# Charlotte-Mecklenburg Planning Department

**SUBJECT:** Administrative Approval for Petition No. 1998-042C Erwin Capital & Crosland Group

# ERWIN CAPITAL/BEAVER FARMS

## SITE PLAN AMENDMENT

SHEET TITLE  
SITE PLAN AMENDMENT  
TECHNICAL DATA SHEET

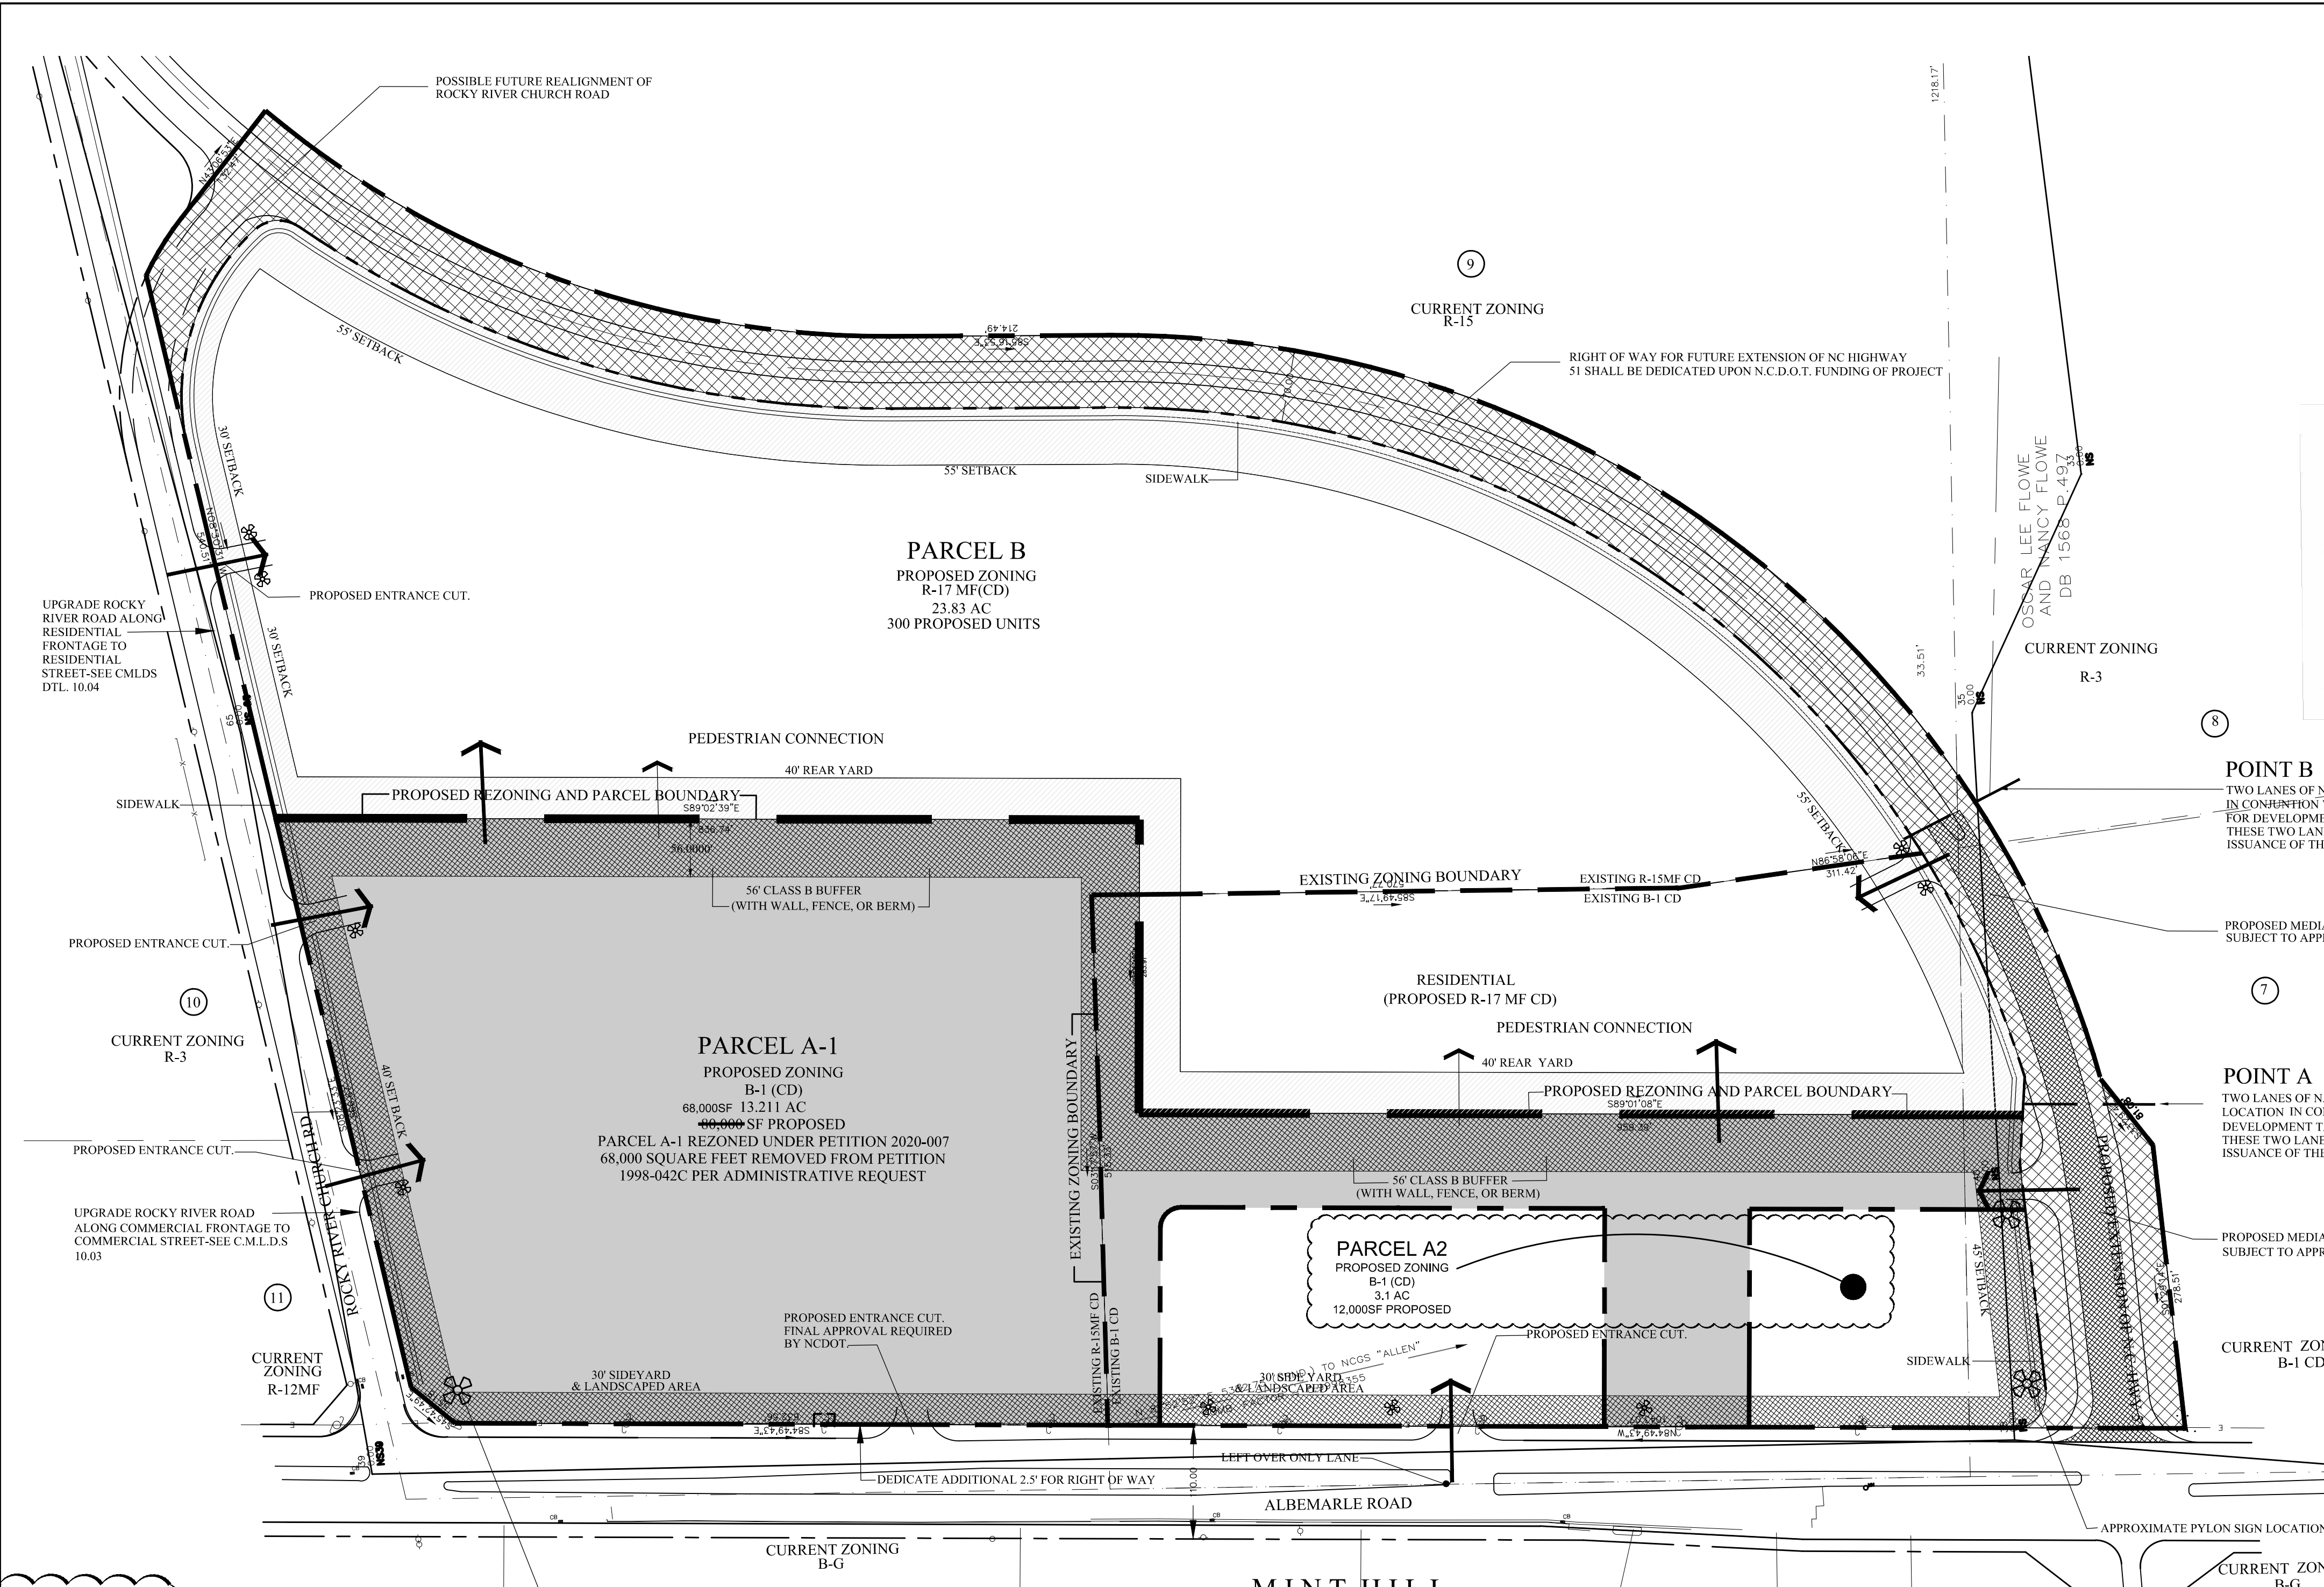
- To modify entitlements for a portion of the site rezoned under petition 2020-007.

Parcel A-1 has been removed from and is not subject to the approved rezoning plan for Rezoning Petition No. 1996-42 (c) pursuant to Rezoning Petition No. 2020-007 and this administrative amendment.

SHEET NO. 2 OF 2  
FILE NAME: 18021/18021B06.DWG

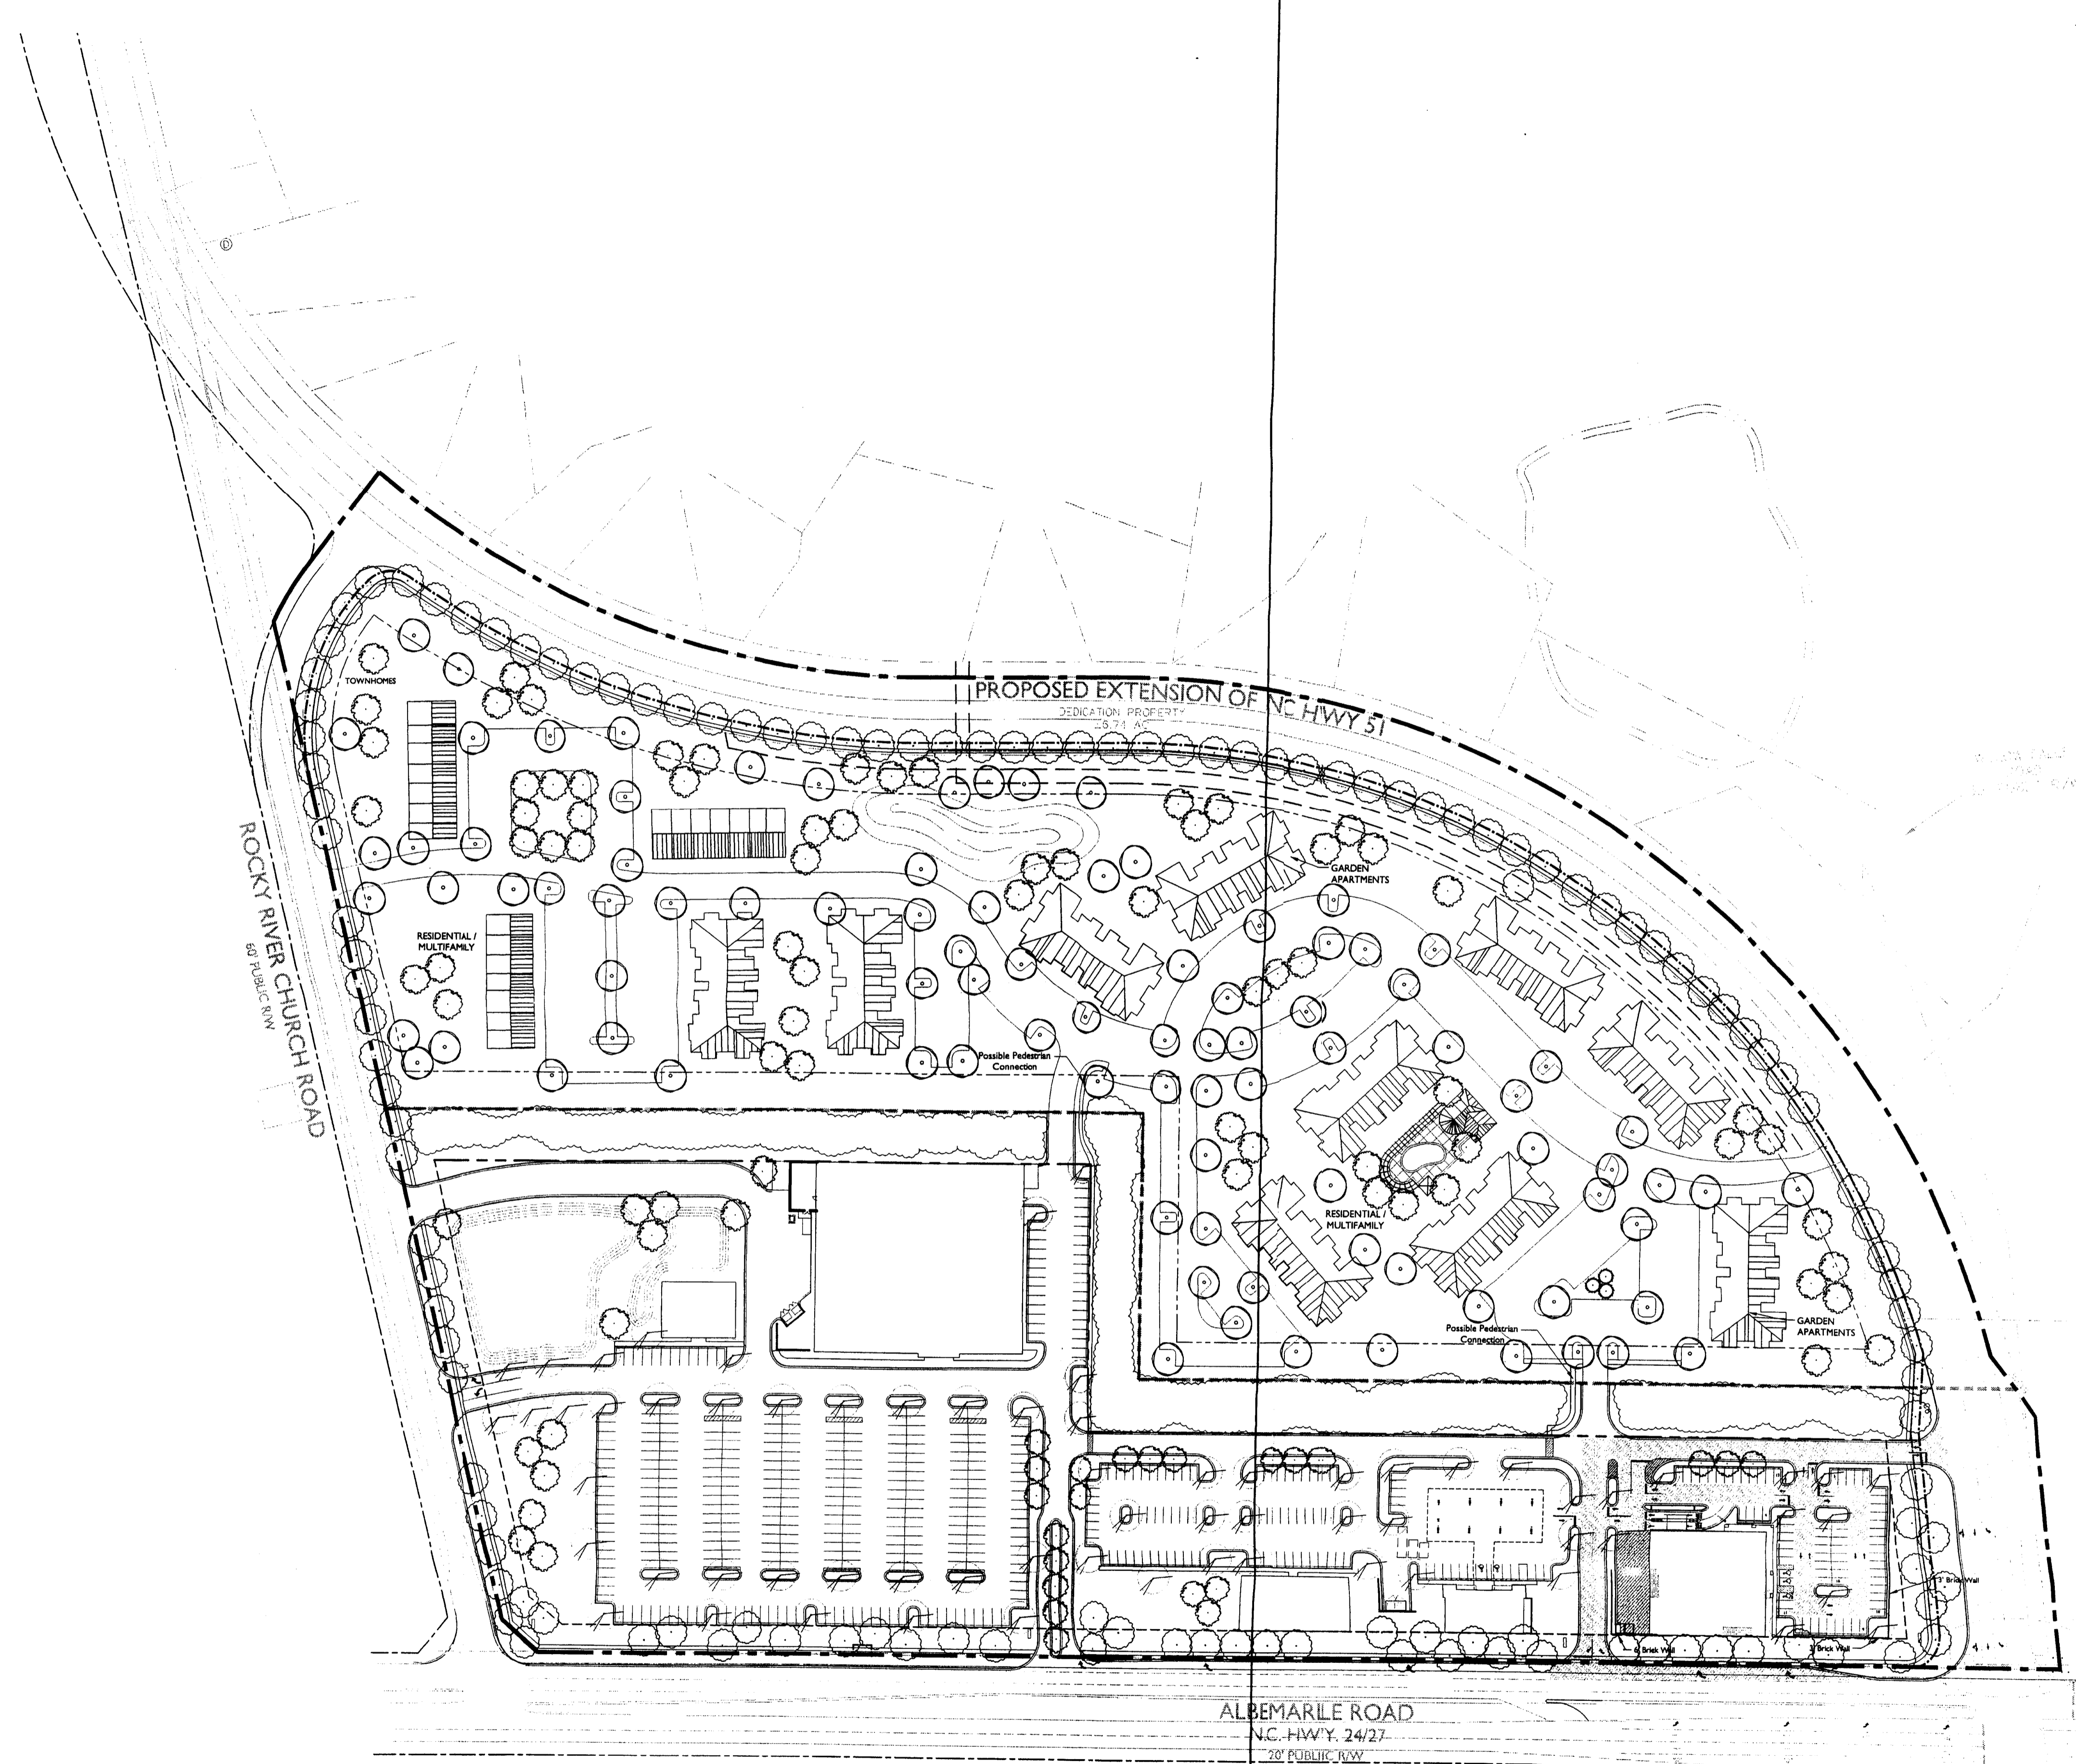
Attached is a revised sketch plan sheet 2 and elevations for the drug store. Since this plan reflects minor changes to the site layout and does not alter the intent of the original site plan, I am administratively approving this revised plan and elevations. Please use this revised plan and elevations when evaluating requests for building permits and certificates of occupancy.

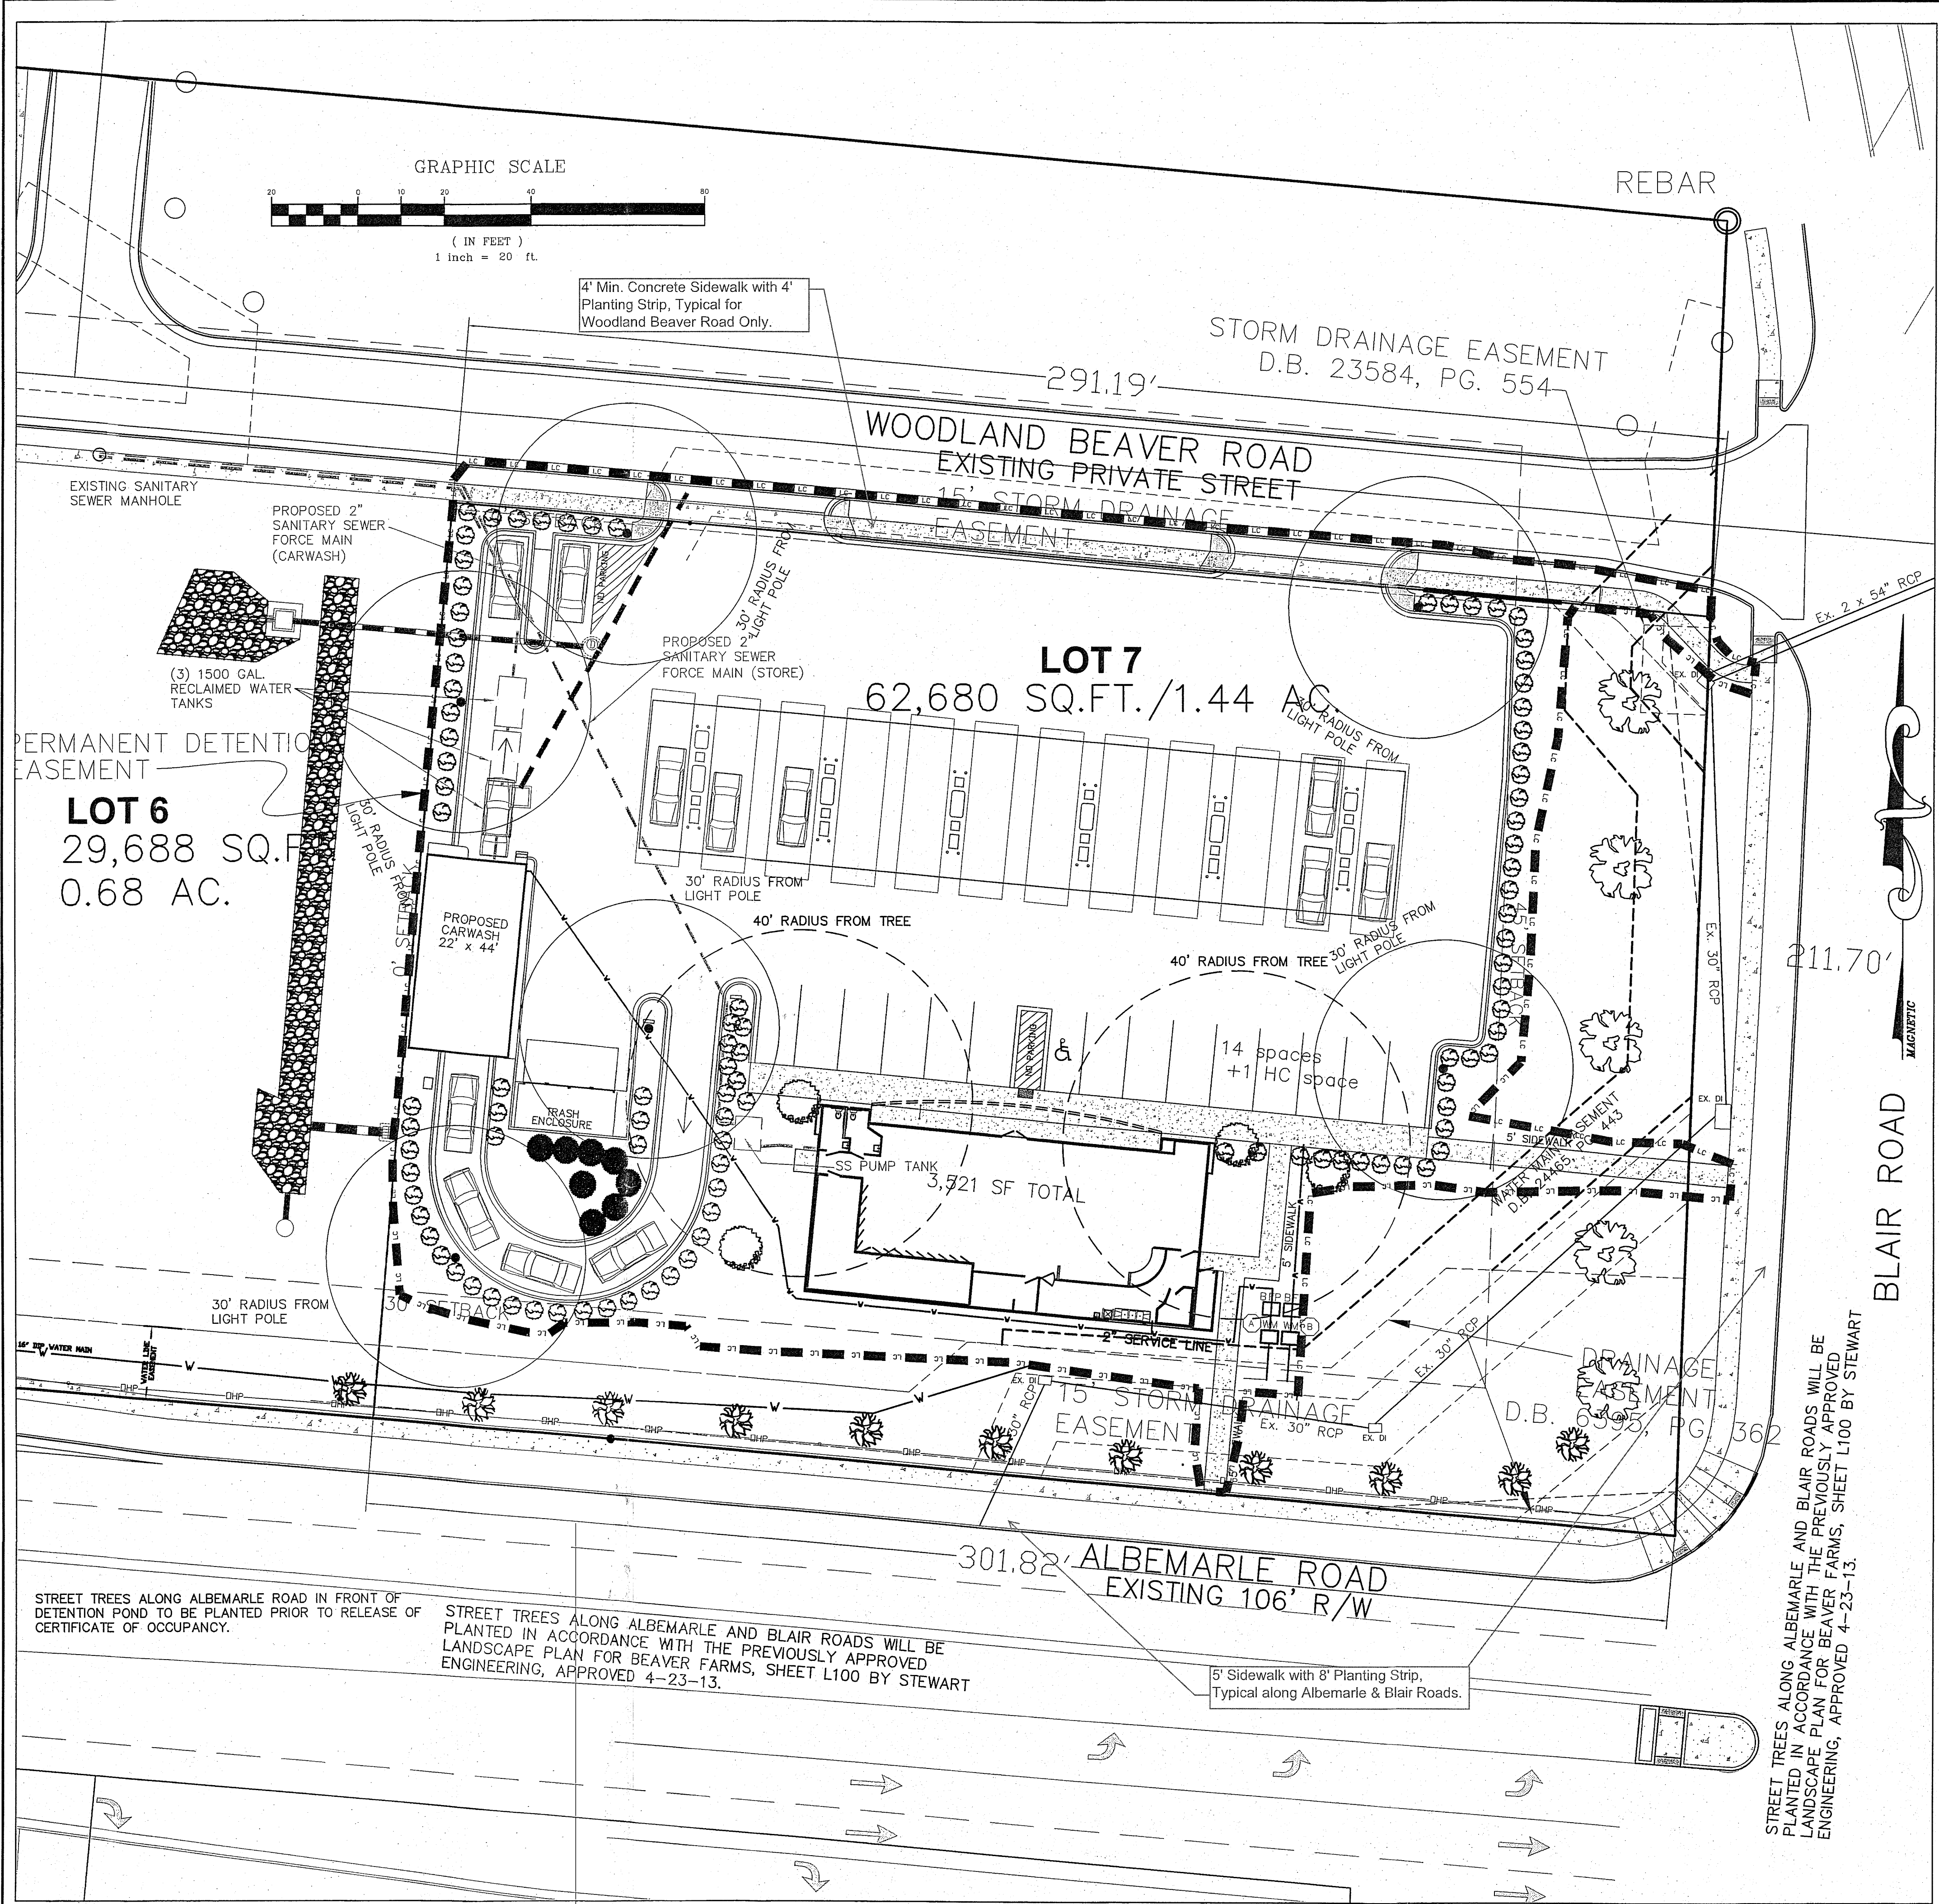
- Proposed building elevations for the proposed convenience store with accessory pumps.
